Re: Station 5 Addition and Remodel

FIRE STATION #5 ADDITION

ADDENDUM 1

August 9, 2005

**BASE BID - BUILDING PARTIALLY SPRINKLERED
FIRE SEPARATION/SPRINKLER SCOPE PLAN**

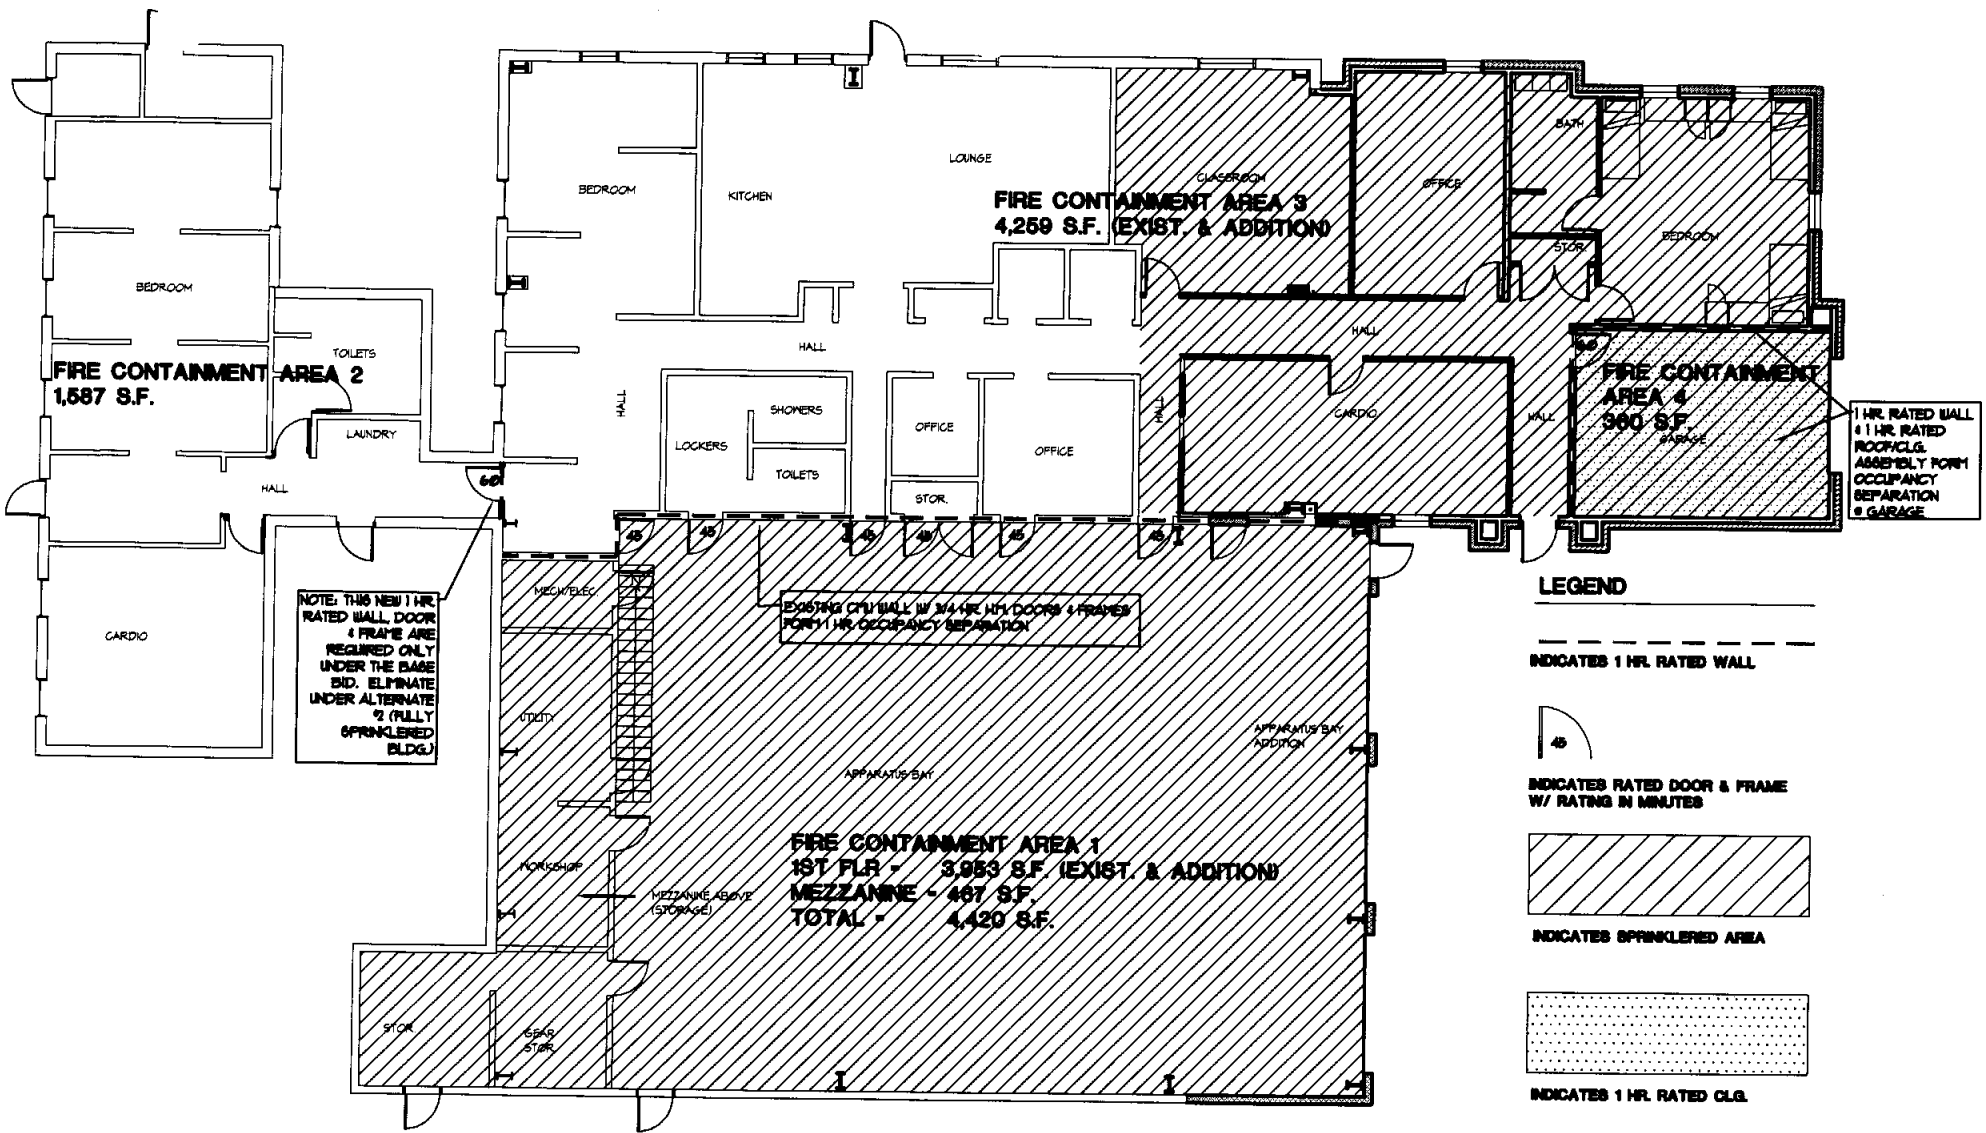
Note that the scope of new fire sprinkler coverage under the Base Bid includes all of the Office/Bedroom Addition and extends into the eastern portion of existing

building where new ceilings are being installed as part of the addition. Note that this extent of coverage is shown incorrectly on the Fire Suppression Plan on sht. FP1 of the Mechanical/Plumbing Drawings, because it does not indicate this area to be sprinklered as part of the Base Bid.

Note that under the Base Bid a 1 hr. rated wall, door and frame are added to separate the existing west wing from the rest of the building and thereby separate the building into Fire Containment Areas that are less than 5,000 s.f. See Addendum item 9 below.

ALTERNATE #2 - BLDG. FULLY SPRINKLERED FIRE SEPARATION/SPRINKLER SCOPE PLAN

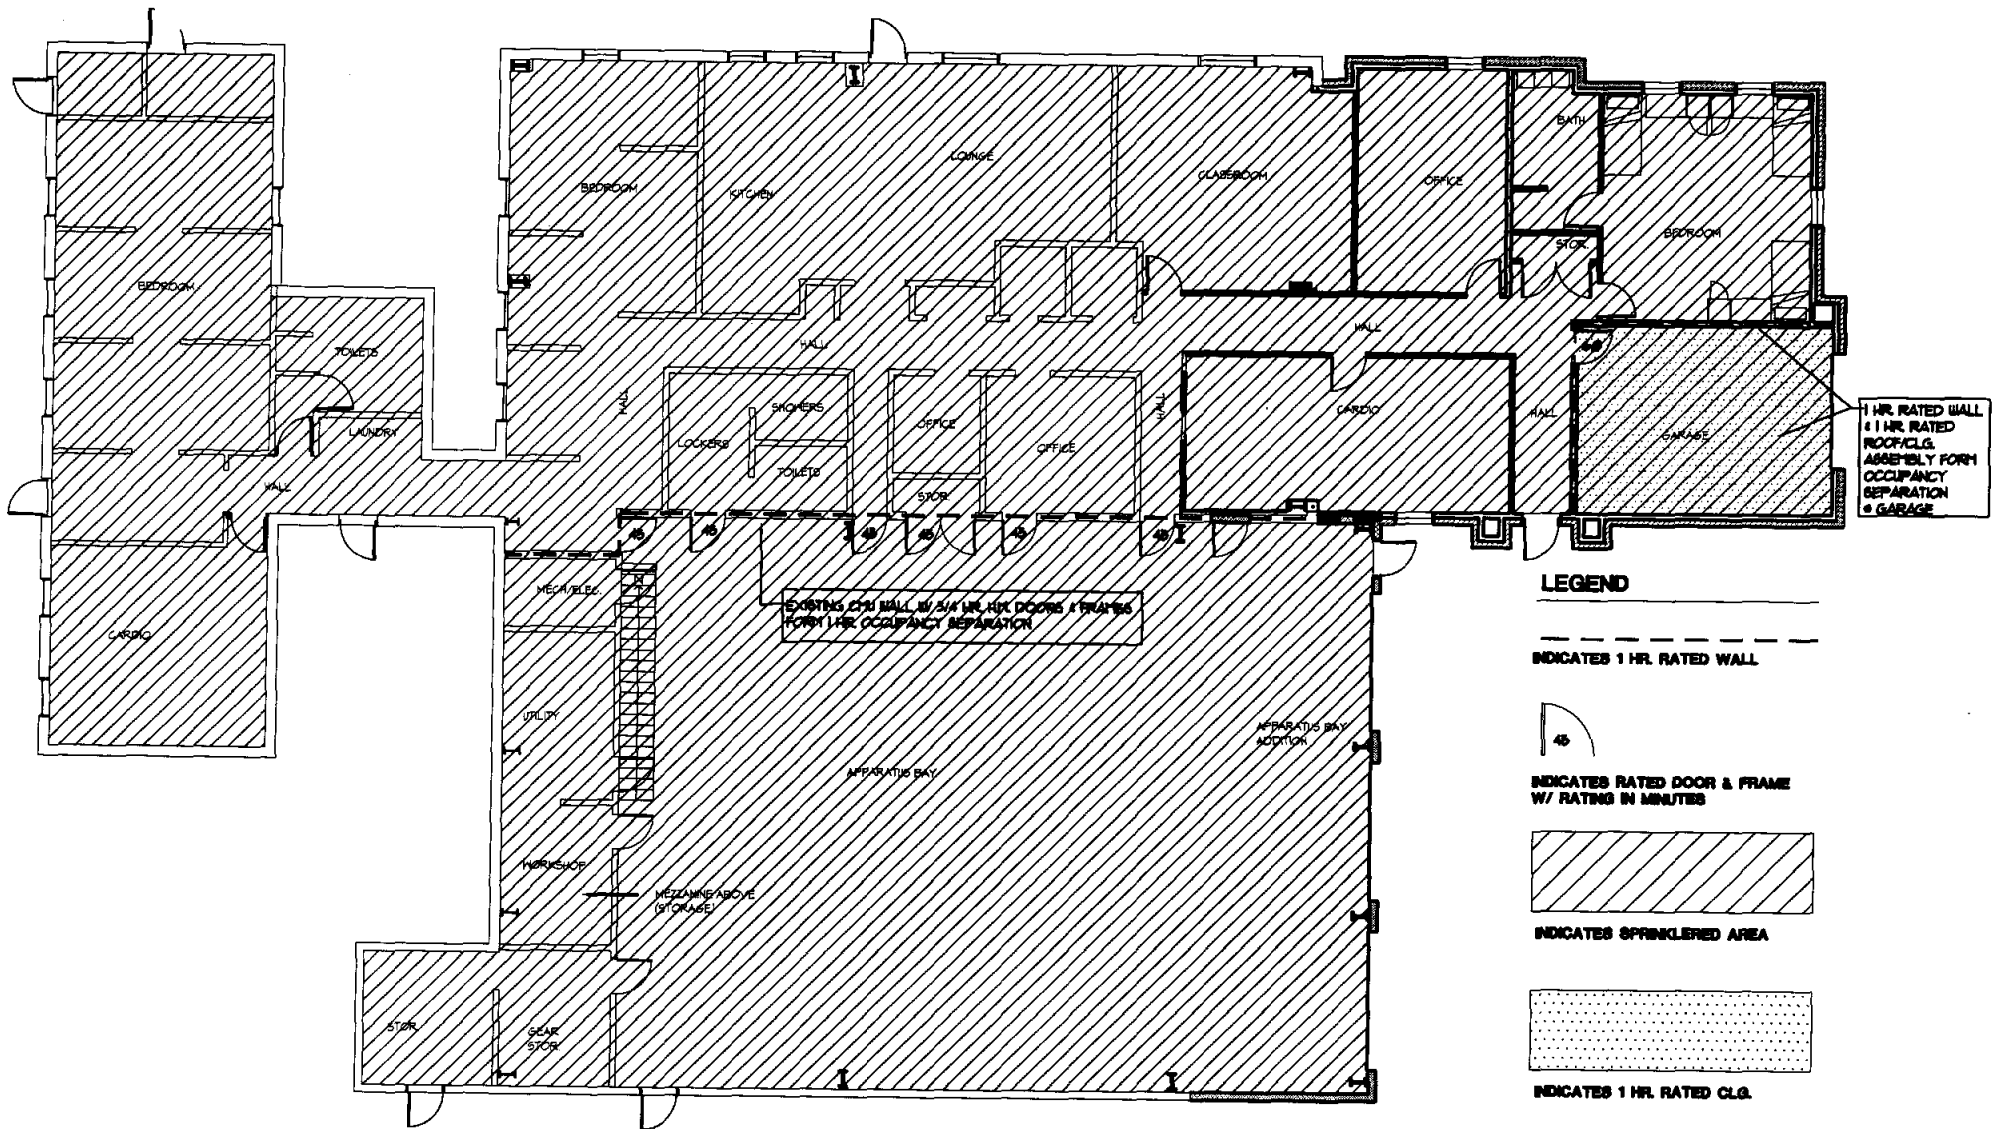
6. Re: Re: Systems Notes Exterior CMU walls W2 & W2A: Add the following: Fill all ungrouted cells with pourable masonry insulation (Perlite or approved substitution).
7. Re: Sht. A7.2 detail 6 PVC Window Head Detail and detail 2 Exterior Door/Window W/ Aluminum Frame in Stud Wall (Head). The soldier course and projected rowlock courses shown above the window and door frames is incorrect. Brick above the doors and windows will be flush running bond as shown on the Elevations Sht. A2.1.
8. Add Sht. A01. Fire Separation/Sprinkler Scope Plan with plans 1: Base Bid – Building Partially Sprinklered - Fire Separation/Sprinkler Scope Plan and 2: Alternate #2 – Building Fully Sprinklered - Fire Separation/Sprinkler Scope Plan. See attached drawings.

1/A1.1 Partial Floor Plan

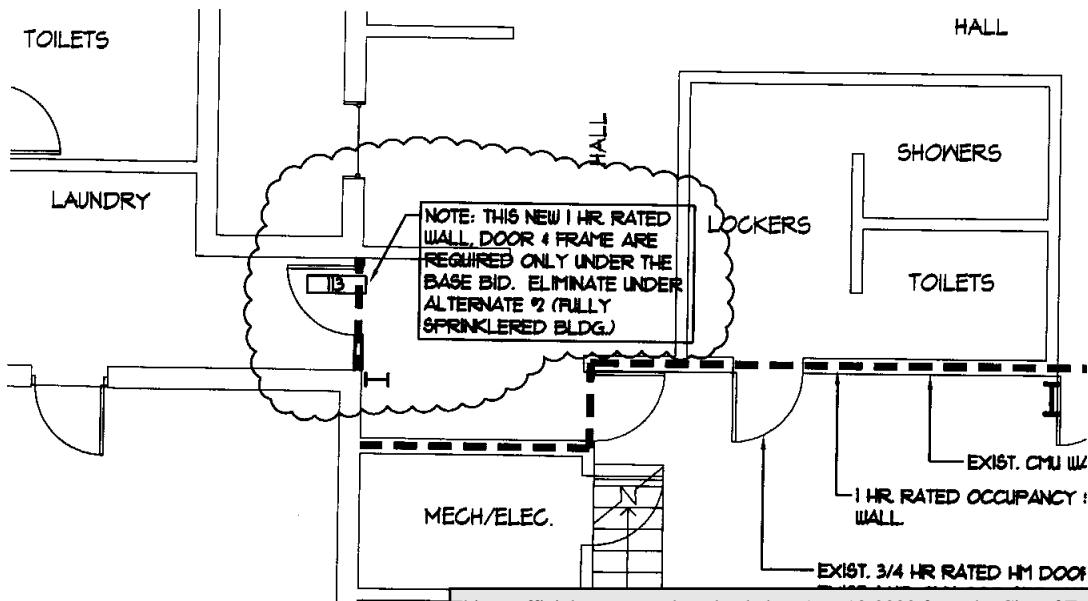
9. Re: attached 1/A1.1 Partial Floor Plan & A7.1 Revised Door Schedule. Add new 1 hr. rated wall and Door & Frame 113 to separate the existing west wing from the rest of the building. Note that this wall, door & frame are only required under the Base Bid, and are not to be included under Alternate #2 (Fully Sprinklered Building).

**POUDRE FIRE AUTHORITY
STATION NO. 5
REVISED WATER
AND FIRE LINES**

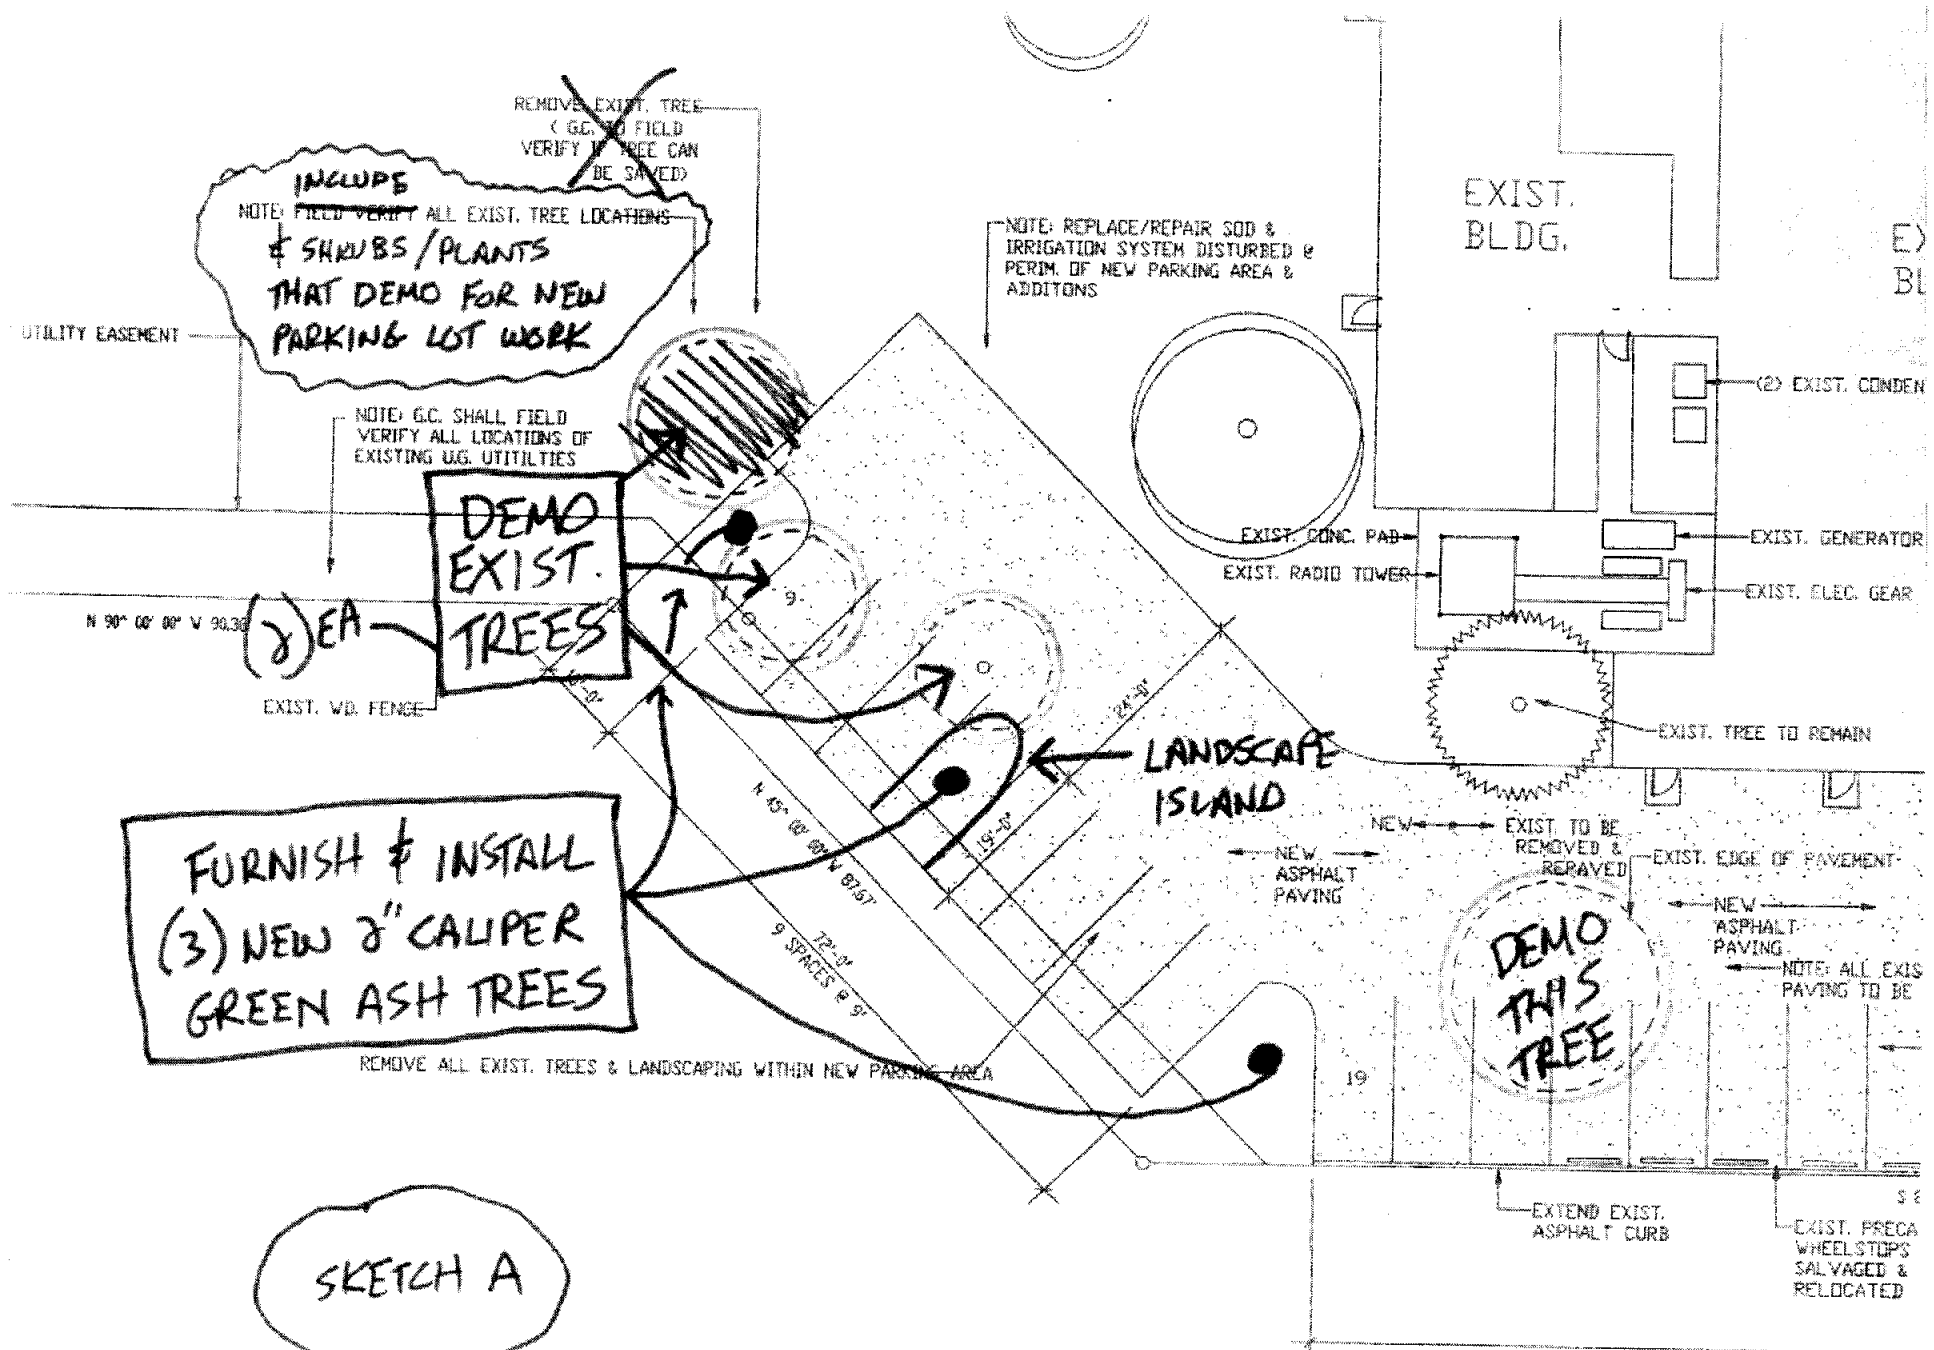
1. Existing overhead doors on the Apparatus Bay are to be removed, salvaged & delivered to the Owner at 3400 Vine Drive, Ft. Collins.
2. Re: Civil drawing C-4 Grading & Utility Plan. New water service is shown coming into the SW corner of the Apparatus Bay Addition. This is incorrect. It is to come into the SW corner of the Office/Bedroom Addition. The sprinkler valve is located in the SW corner of the Garage in the Office/Bedroom Addition. See attached sketch 1 of 1 Revised Water And Fire Lines

SKETCH A

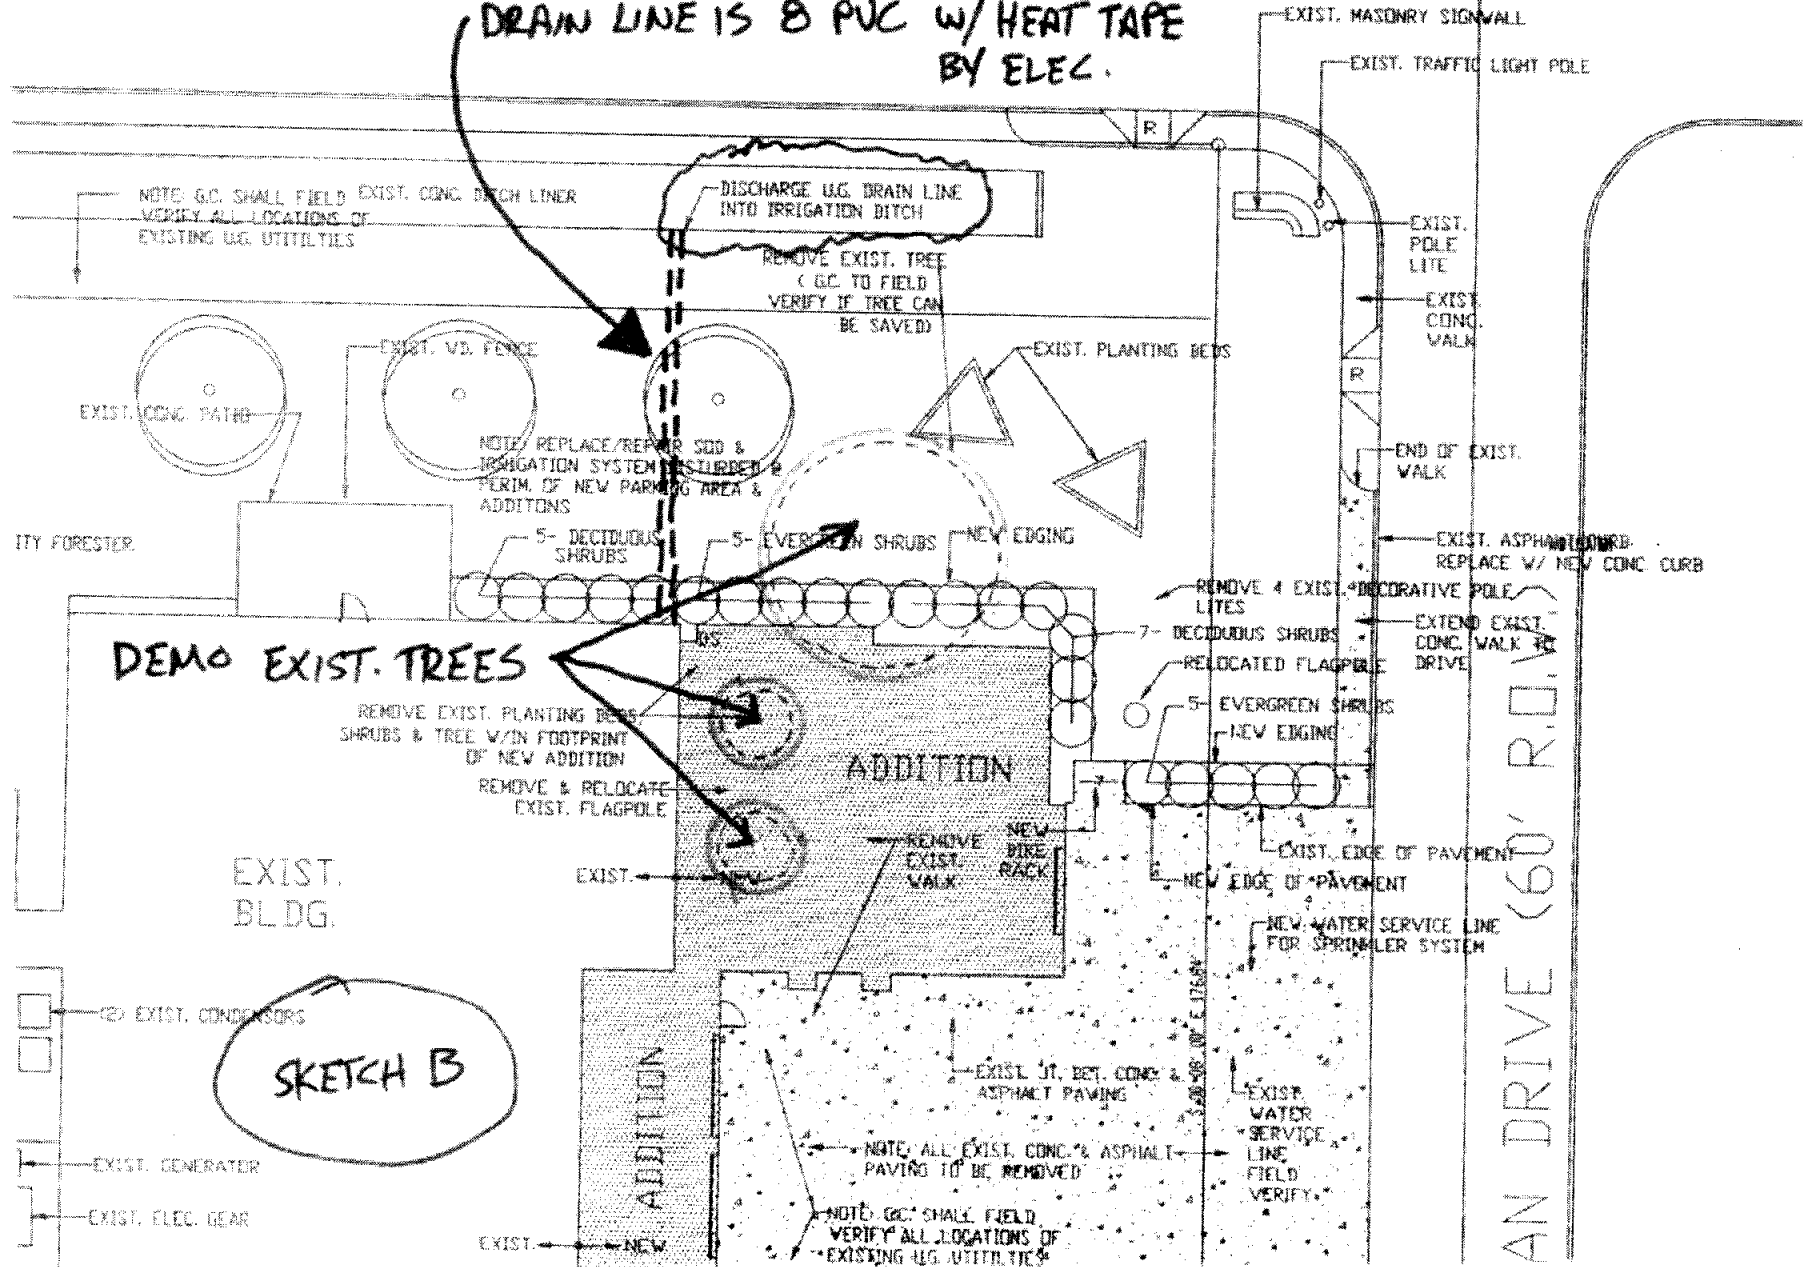
12. See sketches A and B attached with this addendum to clarify trees that are to be removed, and new trees added to the landscape plan.
13. See sketch B for location of drain line, this includes heat tape by electrical contractor. Landscape contractor to include irrigation and landscape repair for the installation of this new line to the existing irrigation ditch on the north end of the property.

INCLUDE
 NOTE: FIELD VERIFY ALL EXIST. TREE LOCATIONS
 & SHRUBS/PLANTS
 THAT DEMO FOR NEW
 PARKING LOT WORK

REMOVE EXIST. TREE
 (G.C. TO FIELD
 VERIFY IF TREE CAN
 BE SAVED)

NOTE: REPLACE/REPAIR SOD &
 IRRIGATION SYSTEM DISTURBED @
 PERIM. OF NEW PARKING AREA &
 ADDITIONS

DEMO
 EXIST.
 TREES

FURNISH & INSTALL
 (3) NEW 8" CALIPER
 GREEN ASH TREES

REMOVE ALL EXIST. TREES & LANDSCAPING WITHIN NEW PARKING AREA

DRAIN LINE IS 8" PVC W/ HEAT TAPE BY ELEC.
